Comments on the Applicant's Response to my Deadline 8 Submission - by Dr David Moore.

Dr David Moore MA (Cantab) PhD CEng FIMechE
Unique Reference Number: 20040614

Part 2 of 3 - Investigation

Figure 10. Sectional View through NMP4 and Billington Lakes showing Daytime Ambient Noise $L_{Aeq16hr}$ versus Distance from Nearside Rail

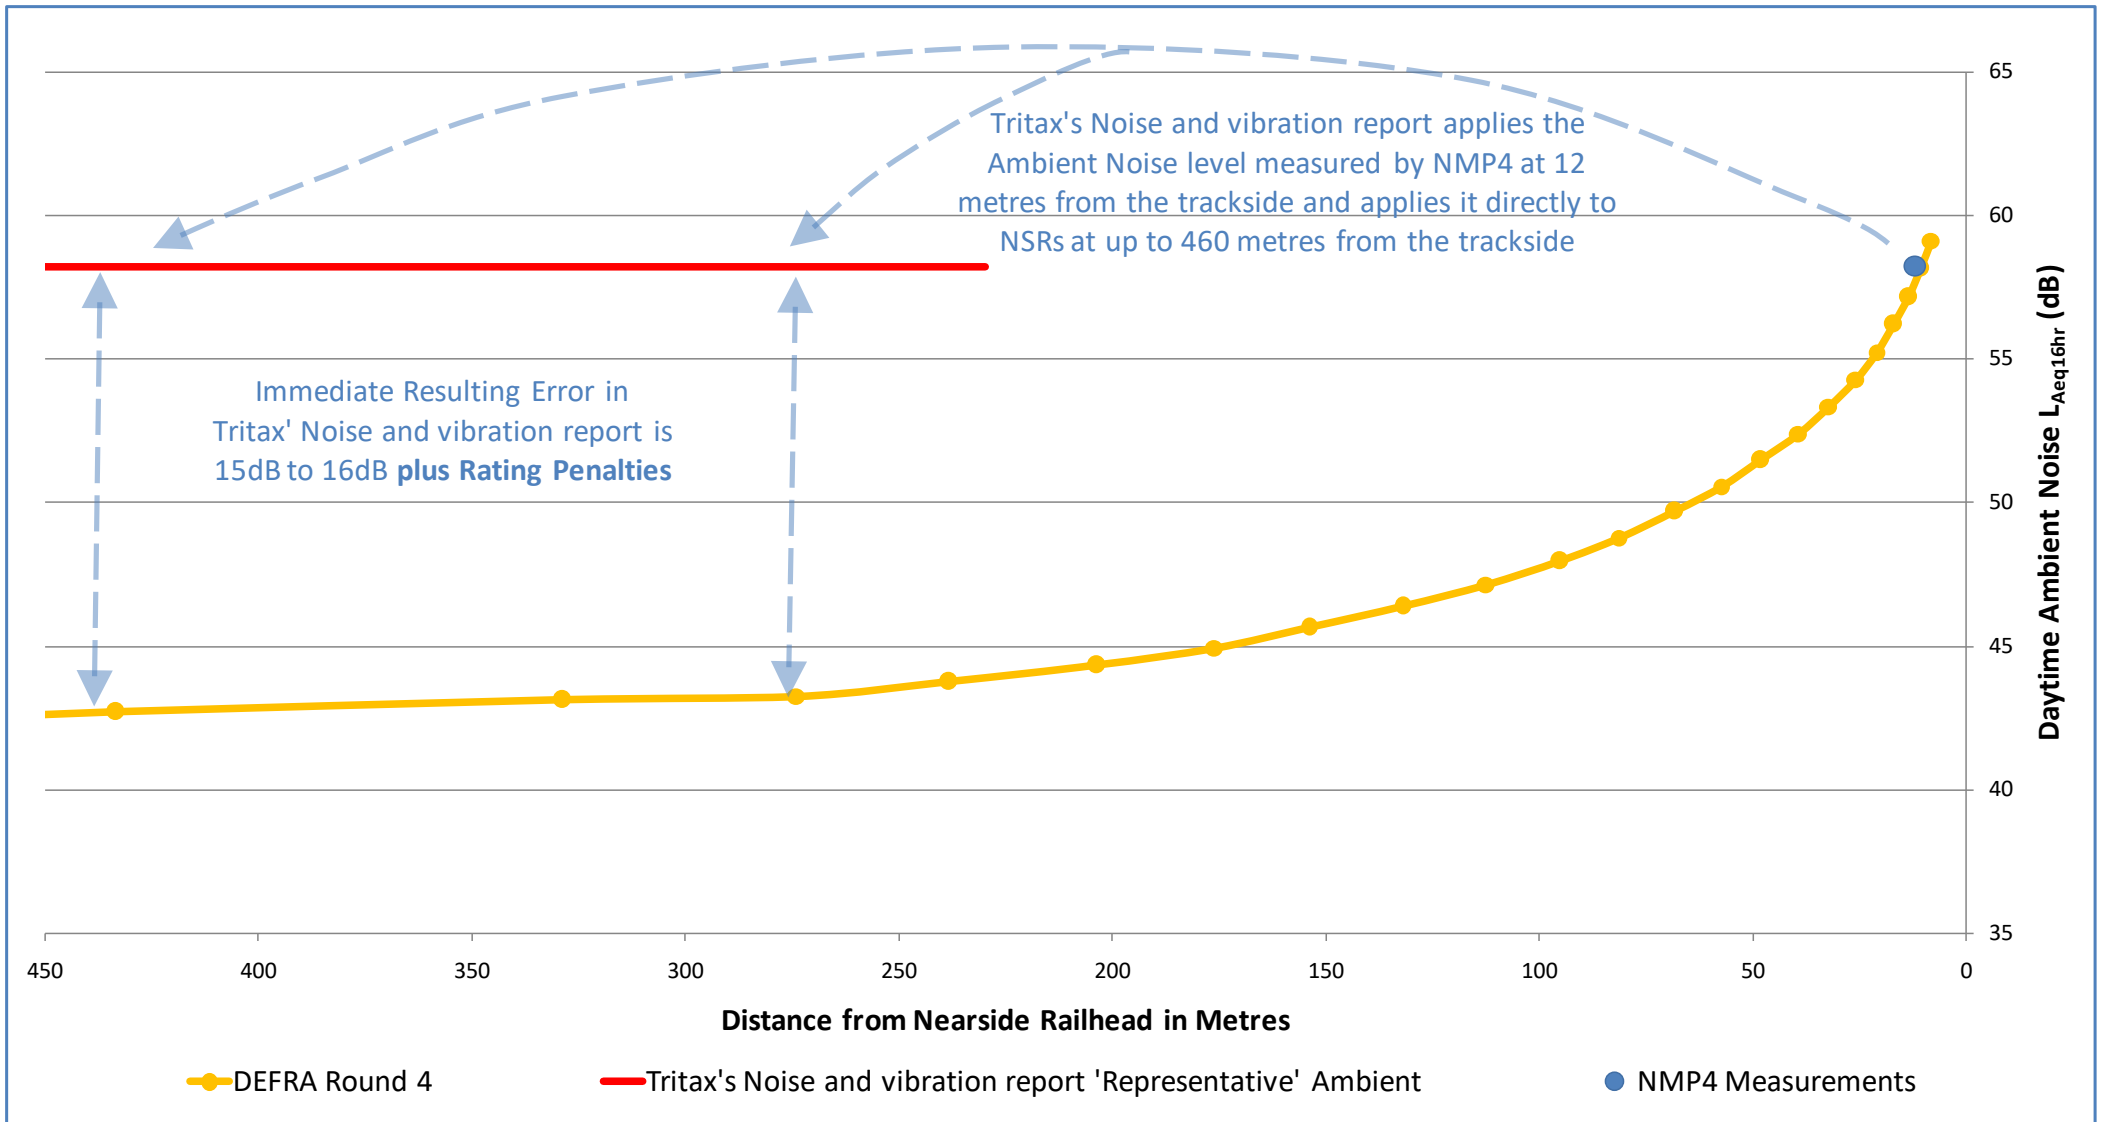
This is best explained with reference to the further Sectional View shown in Figure 10. This time, though, rather than showing the DEFRA Round 4 Daytime Rail Noise Contour and the DEFRA Daytime Road Noise Contour separately in two Sectional Views in Figures 6 and 8 as I did previously, instead in Figure 10 I now show those two Daytime Noise Contours combined together into a single DEFRA Round 4 Daytime Ambient Noise Contour. The combination of the DEFRA Round 4 Daytime Rail and Road Noise levels into the DEFRA Round 4 Daytime Ambient Noise level is performed by logarithmic addition.

With reference to Figure 10, what Tritax have done in their Noise and vibration report is to take the Ambient Noise measured at NMP4 at 12 metres from the trackside, and apply it directly to NSRs at very considerably greater distances from the trackside without applying any form of attenuation at all. This is represented in Figure 10 by the curved Blue Arrows. So the Daytime Ambient Noise Level that Tritax apply to the NSRs in their Noise and vibration report is identical to the Daytime Ambient Noise level measured at NMP4 at 12 metres from the trackside, and is indicated in Figure 10 as the thick Red Line. With reference to Section 3, this Daytime Ambient Noise Level at NMP4 is 58.2dB.

In Figure 10, the Ambient Noise level at the NSRs is actually indicated by the DEFRA Round 4 Daytime Ambient Noise level, shown in Gold. This is very much lower than Tritax's thick Red Line, and the

Indeed, in Figure 10, it is extremely clear that the Daytime Ambient Noise at such NSRs is very much less than the Daytime Ambient Noise level that Tritax have applied to them. This means that Tritax's Noise and vibration report is very seriously wrong and indeed is fundamentally flawed.

The errors that **immediately** result from Tritax's methodology are shown in Figure 10 to be in the region of 15dB to 16dB.

Figure 11. Sectional View through NMP4 and Billington Lakes showing Night Time Ambient Noise L_{night} versus Distance from Nearside Rail

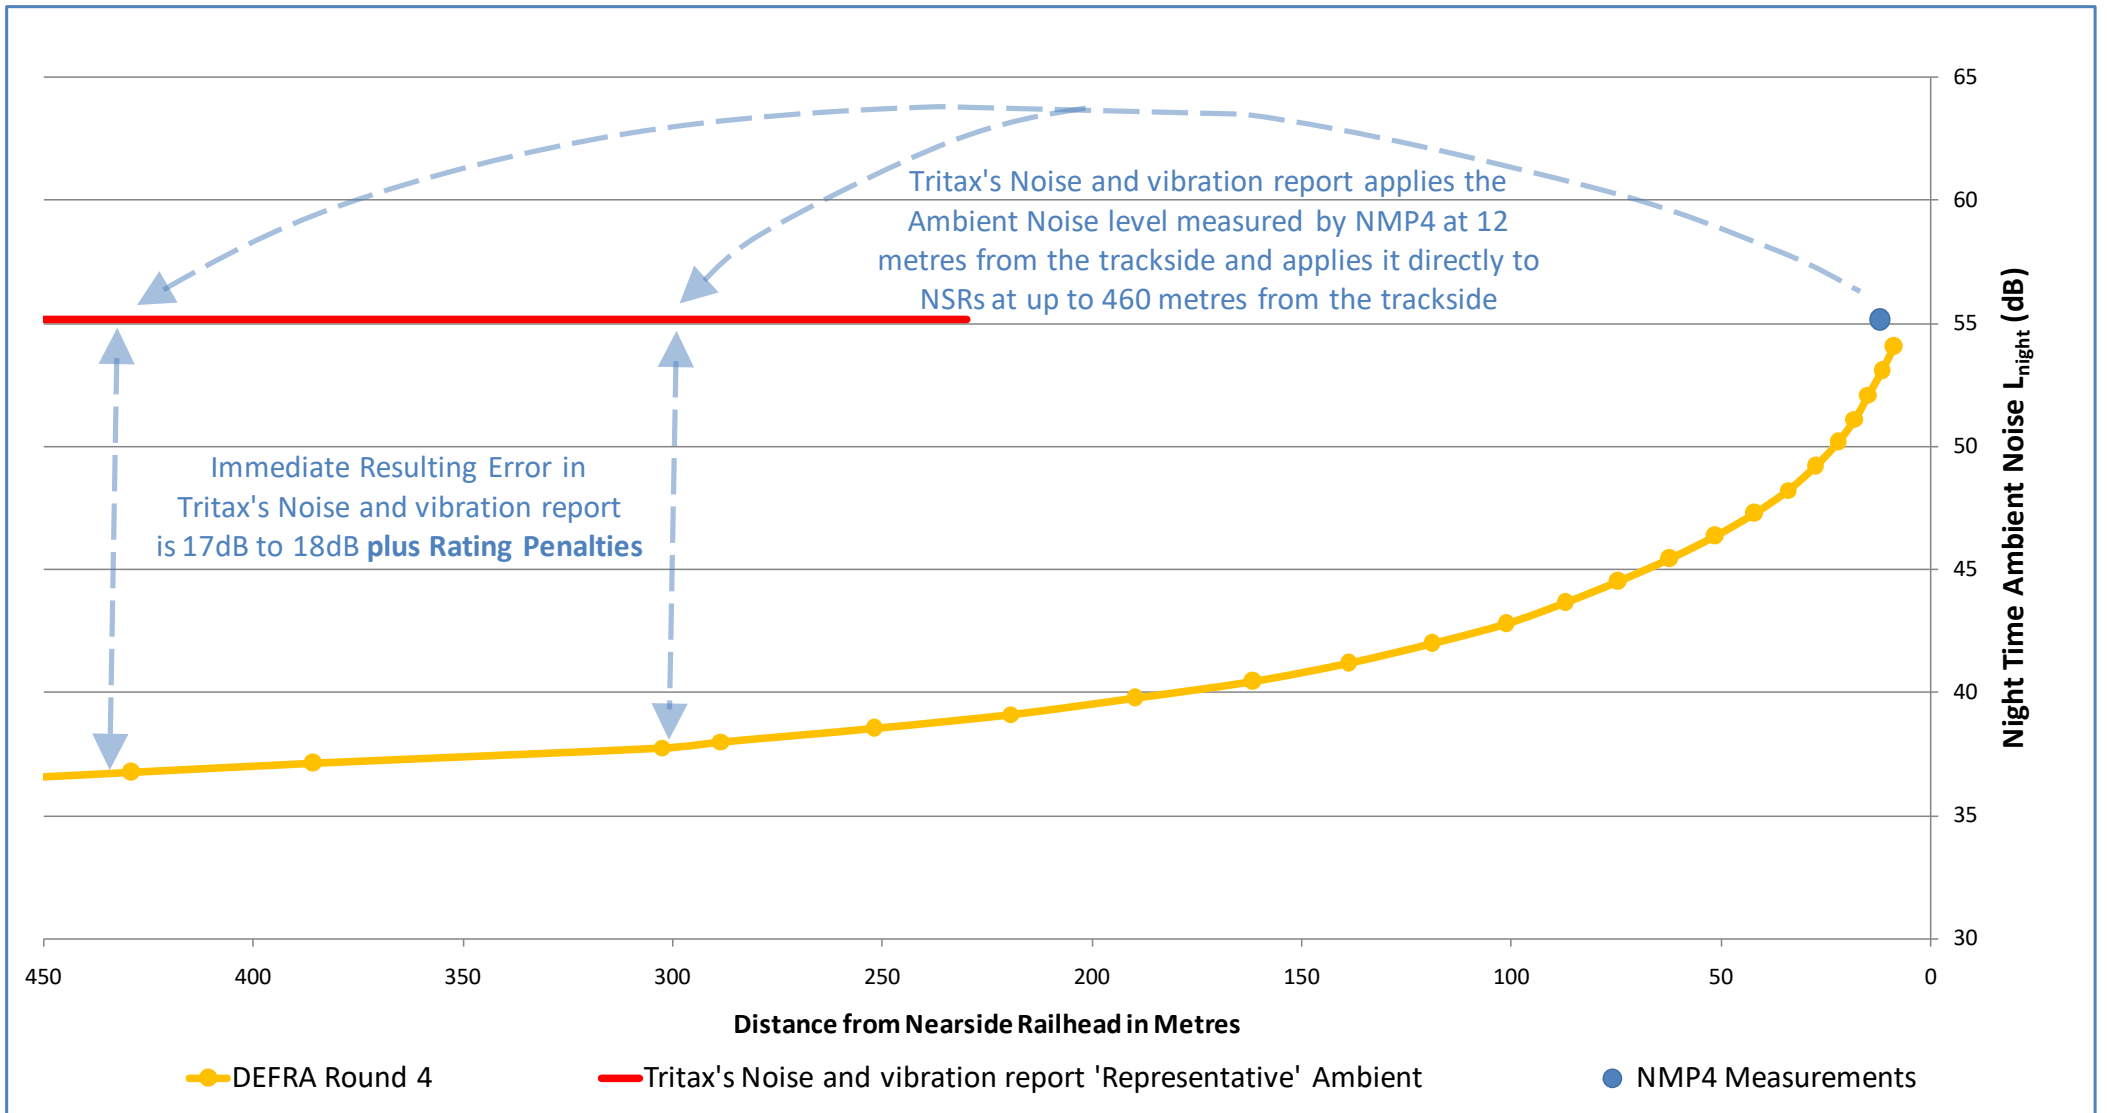
Turning now to the **Night Time** Ambient Noise, in Figure 11 I show a further Sectional View in which all of the Daytime Parameters I described above in respect of Figure 10 have been duly replaced by their Night Time equivalents. All of the Key colour codings again remain the same.

With reference to Section 3, the Night Time Ambient Noise Level measured at NMP4 at 12 metres from the track is 55.1dB, and Tritax again apply this directly to NSRs at very considerably greater distances from the trackside without applying any form of attenuation at all. This is represented in Figure 11 by the curved Blue Arrows as before. So the Night Time Ambient Noise Level that Tritax apply to the NSRs in their Noise and vibration report is identical to the Night Time Ambient Noise level measured at NMP4 at 12 metres from the trackside, and is again indicated in Figure 11 as the thick Red Line.

The errors that **immediately** result from Tritax's methodology are shown in Figure 10 to be in the region of 17dB to 18dB.
